FILE NUMBER: Z223-272(JA) **DATE FILED:** May 31, 2023

LOCATION: Property bounded by Millmar Drive, Shiloh Road, Healey Drive, and Casa Oaks Drive

REQUEST: An application for a Specific Use Permit for a public school other than an open-enrollment charter school on property zoned an R-7.5(A) Single Family District.

SUMMARY: The applicant proposes to construct a new public elementary school to replace an existing public school. *[Edwin J. Kiest Elementary School]*

CPC-Recommended SUP Site Plan

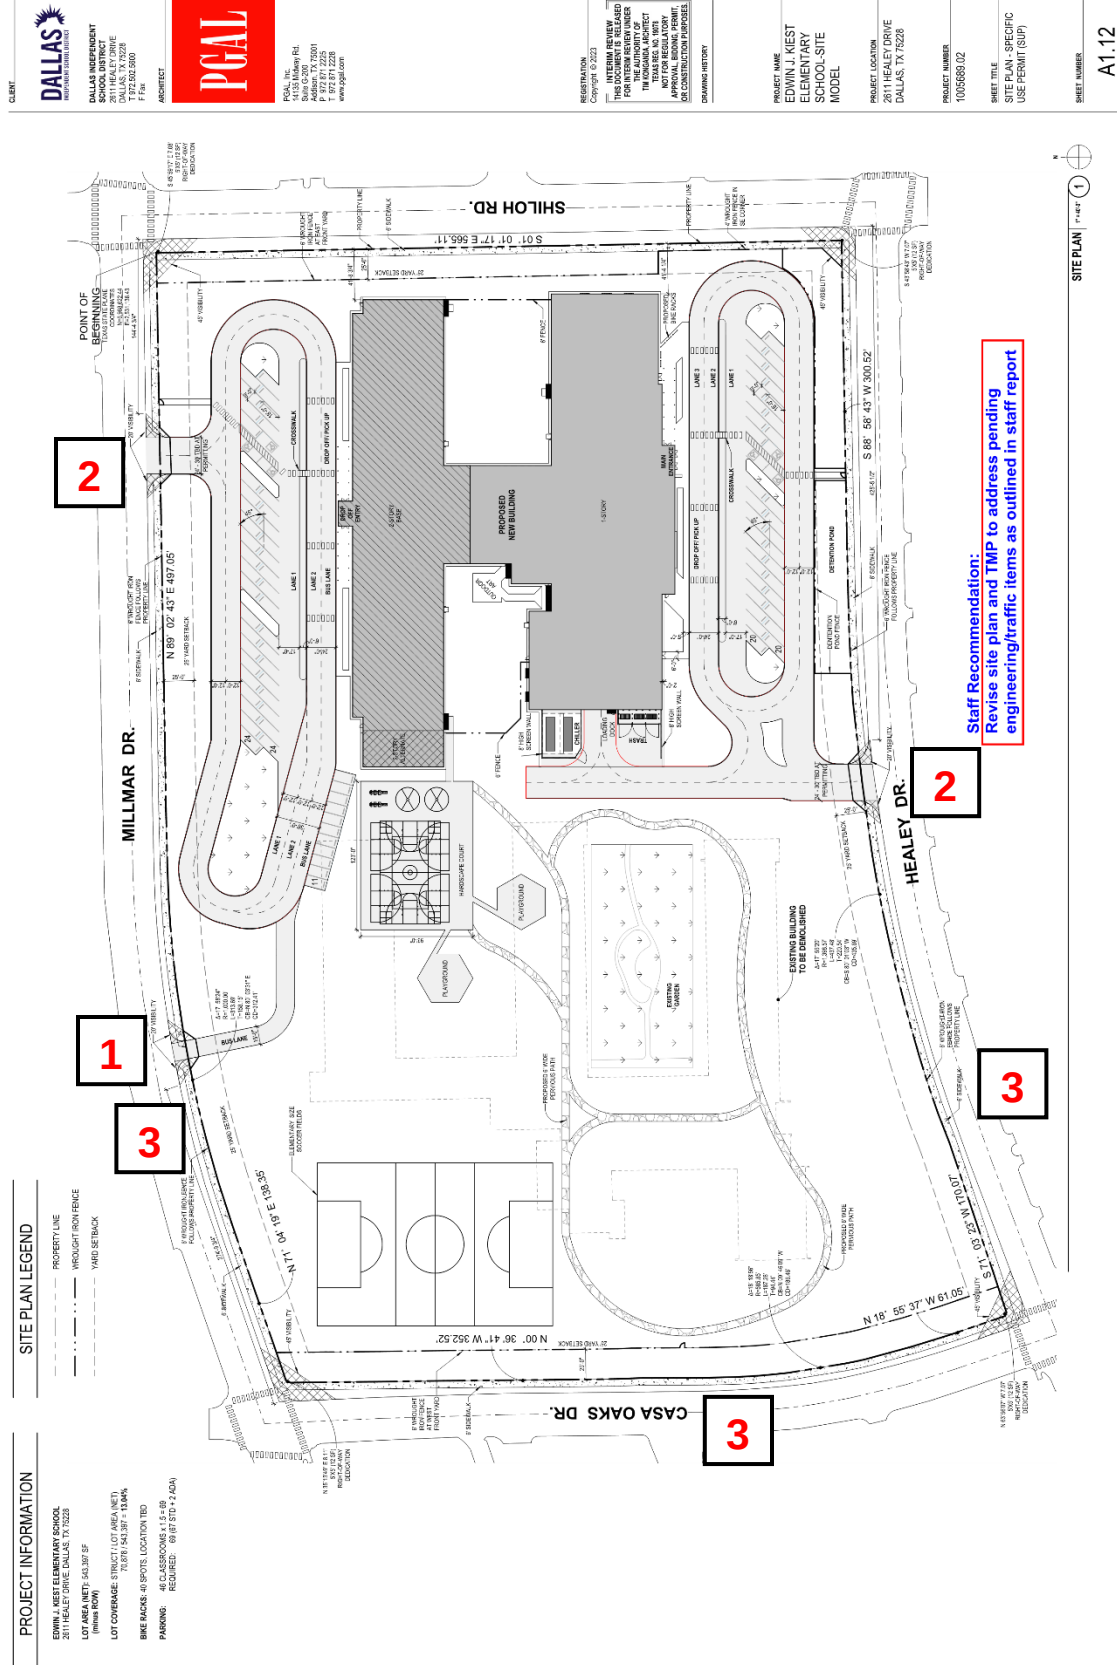
The Transportation Development Services Division of the Transportation Department has reviewed the current zoning request and notes the following pending items (*boxed numbers correspond to numbered locations on CPC-recommended site plan shown later in this report*):

Bus driveway remains unresolved. Staff recommends removal of driveway.

Staff Notes: Staff recommends removal of this additional driveway because it creates an additional conflict point between pedestrians and vehicles. While staff understands that the applicant is proposing the separate bus driveway in an effort to keep buses separate from parent vehicles at peak drop off and pick up times, staff recommendation remains that the separate bus driveway be removed,

Staff recommends a maximum width of 24 feet at vehicle access points (city standard for this use at this location).

CPC-recommended site plan still does not provide sufficient access for pedestrians and bicyclists on the western portion of the property.

The CPC-recommended site plan directs pedestrians and bicyclists to singular access points on the eastern portion of Millmar Drive and Healey Drive, making it virtually impossible for pedestrians/bicyclists to access the property and school building without crossing vehicular access points to the property.

Staff recommends pedestrian/bicycle access, including paved pathways, between building entries and all public rights-of-way. For this location, one additional access point with paved pathway on the western portion of Millmar Drive, one additional access point with paved pathway on Casa Oaks Drive, and one additional access point with paved pathway on the western portion of Healey Drive will provide sufficient access for pedestrians and bicyclists without requiring crossing a vehicular access point.

- Shift pedestrian access :

- At north & south pedestrian access to be located between vehicular ingress/egress and Shiloh Road coordinated with accessible route at parking aisle to combine pedestrian access to building entry

- Add to site plan; a minimum of one pedestrian access located along Casa Oaks Drive
- add dimension at proposed bus drive of 15 ft
- increase pedestrian refuge area at vehicular drives from 3 ft to 5 ft
- Revise site plan to indicate 24 - 30 ft ingress / egress drive aisle with maximum 15 ft curb radii at Millmar Drive and Healy Drive as shown

CPC-Recommended Traffic Management Plan

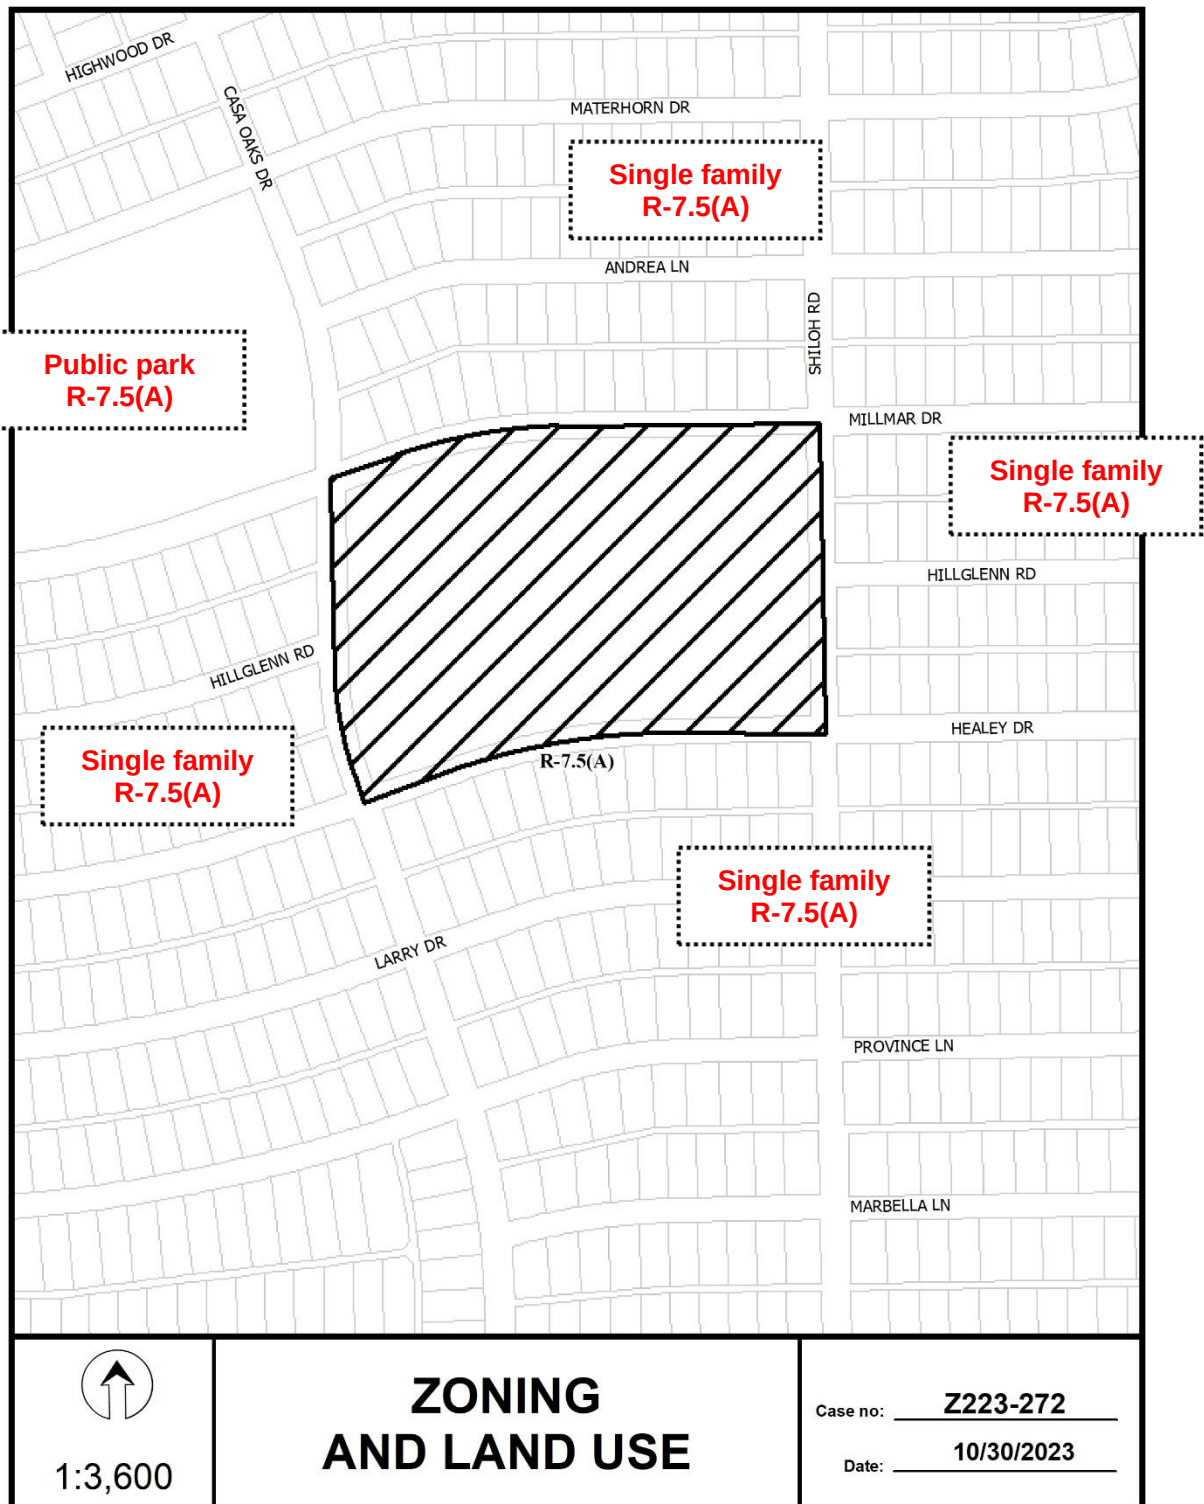
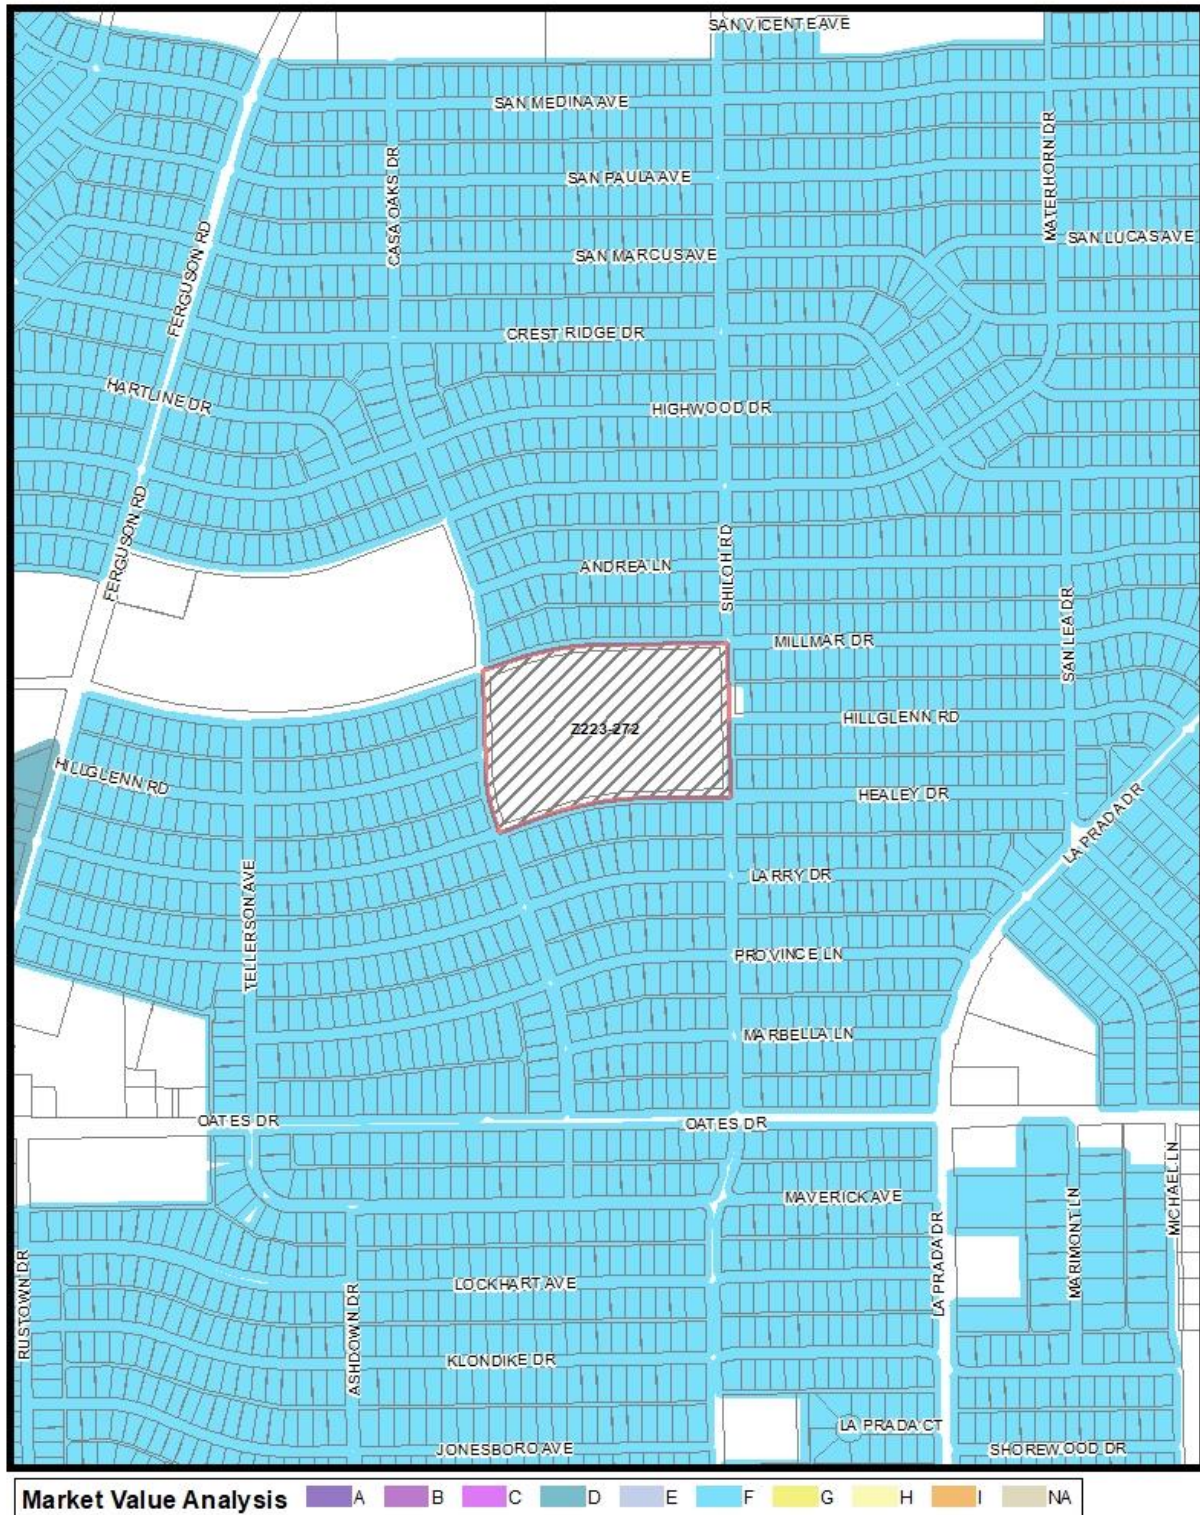
- ADDED COMMENT: the TMP Exhibit 1 notes pedestrian access point: to be indicated on revised exhibit on property zoned an R-7.5(A) Single Family District bounded by Millmar Drive, Shiloh Road, Healey Drive, and Casa Oaks Drive.

Revise site plan and TMP to address pending engineering/traffic items as outlined in staff report
